**PLANNED UNIT DEVELOPMENT  
STAFF REPORT****Date: January 4, 2007****DEVELOPMENT NAME**

McCrary Storage

**LOCATION**4057 Moffett Road  
(South side of Moffett Road at Pine Grove Avenue)**SUBDIVISION NAME**

# SITE PLAN

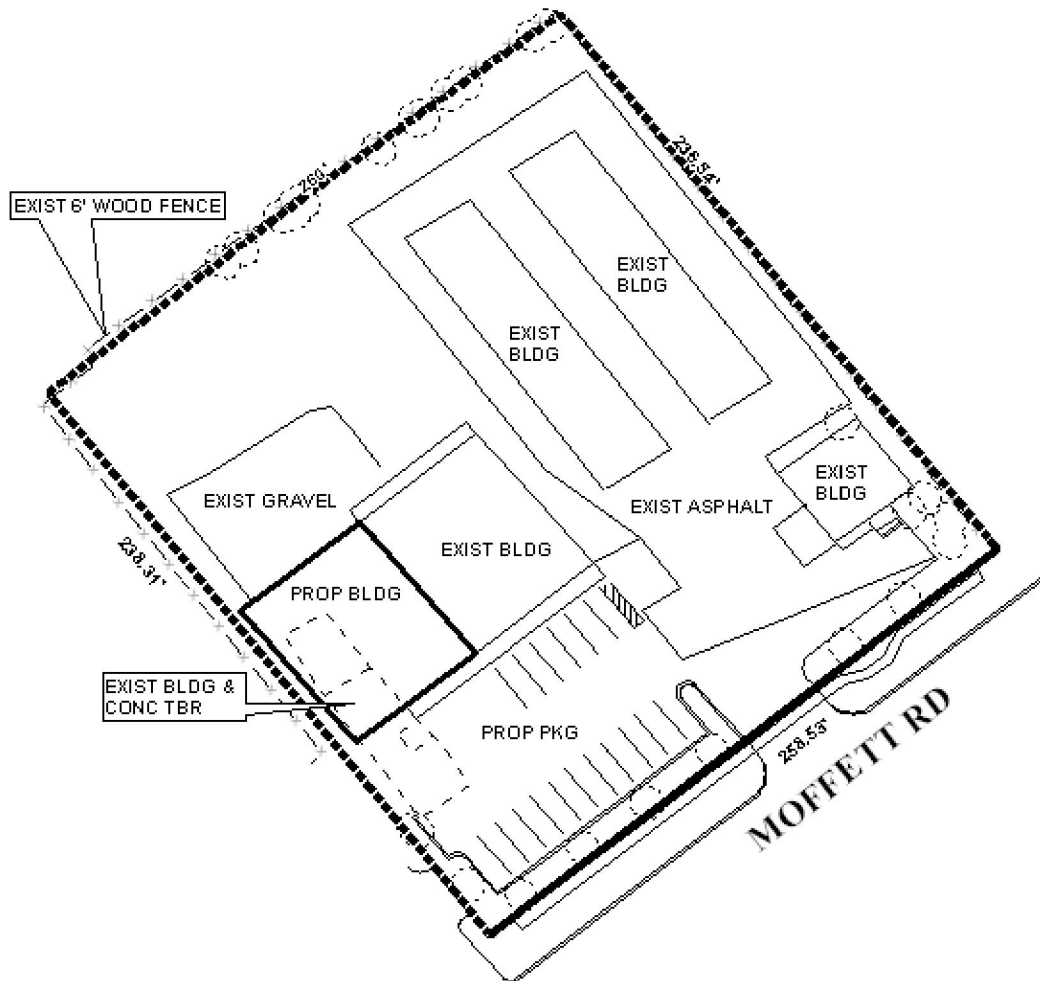
The site was the subject of two prior PUD approvals, the first in 2001 and the second in 2004. The applicant is amending the previously approved PUD to show a proposed building within 5 feet of the East property line (previously shown as 10 feet), and changing the proposed use from offices to a climate-controlled mini-warehouse facility. Mini-warehouse facilities are allowed by-right in B-3 districts, and 5-foot side yard setbacks are allowed where commercial sites abut commercial sites.

The proposed building will increase the impervious area on the property, thus on-site stormwater detention may be required: the detention should be depicted on the site plan, if required.

**RECOMMENDATION:**      **Planned Unit Development:** Based on the preceding, the PUD application is recommended for Approval, subject to the following conditions: 1) compliance with the tree and landscaping requirements of the Zoning Ordinance to be coordinated with Urban Forestry, and to reflect the amount of new construction proposed, with full compliance ultimately required as the site is incrementally redeveloped; 2) compliance with Engineering comments (*Verify existing detention has capacity and functionality to replace existing gravel with additional parking and a building. Must comply with all storm water and flood control ordinances. Any work performed in the right of way will require a right of way permit.*); 3) the provision of a buffer, in compliance with Section 64-4.D.1. of the Zoning Ordinance, where the site adjoins residential zoning; and 4) full compliance with all other municipal codes and ordinances, with the exception of the sidewalk requirement.
